CHANGE ORDER NUMBER: 1HNTB Corporation
Round Rock

Project: 1808-256

Roadway: Ronald Reagan at Santa Rita

Change Order No. 1

Ronald Reagan at Santa Rita Pavement Section Change

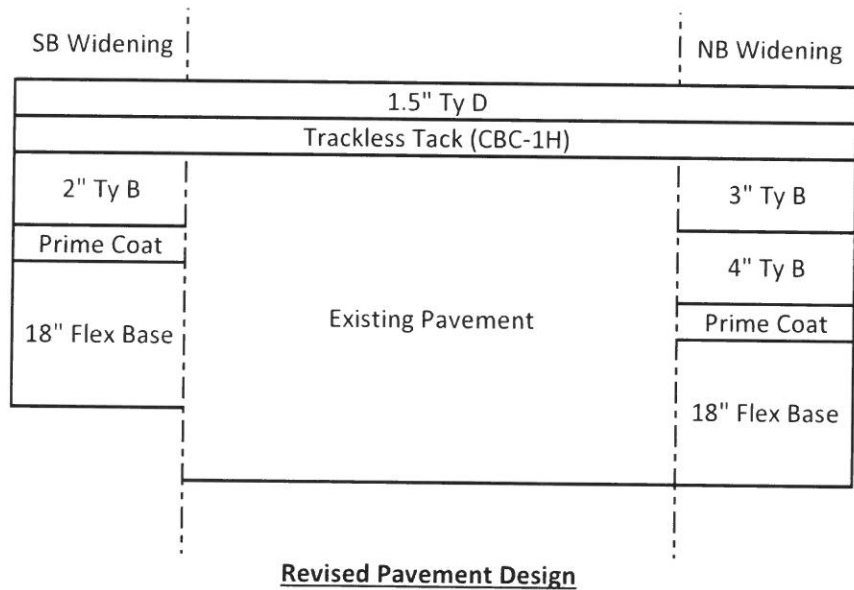
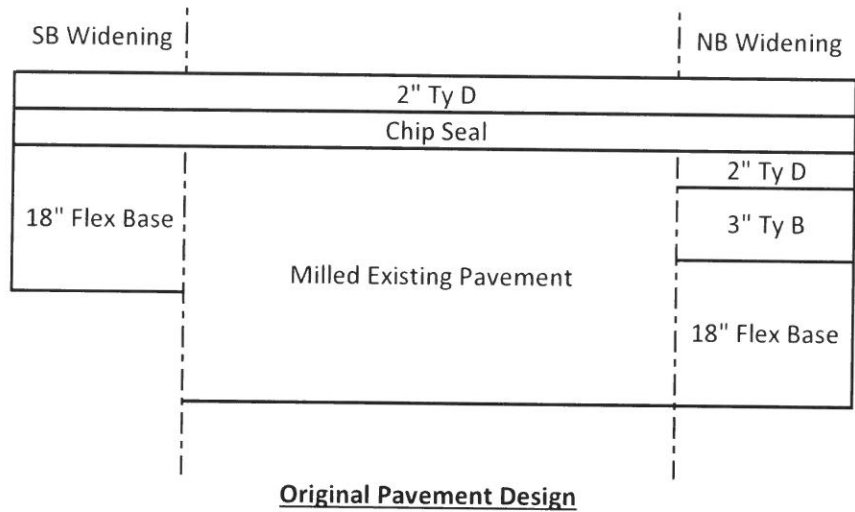
This Change Order provides the final balancing for the overrun/underrun of Contract quantities on the project as a result of addressing field conditions not accounted for in the original plans. Below is a list of major overrun and underrun items, due to the pavement design changes approved by the Engineer. The design changes include eliminating the 2-inch milling of the existing pavement and changing the hot mix section from 4 inches of Type D and 3 inches of Type B to 1.5 inches and 7 inches respectively.

This Change Order also adds two new Contract items. Item 310-6005 PRIME COAT (AE-P) is called out on the plans but is not included in the original bid tab. Item 3019-6001 TRACKLESS TACK was added as a substitute for the seal coat items (Items 316-6175 & 316-6466), due to low ambient and pavement temperatures during paving.
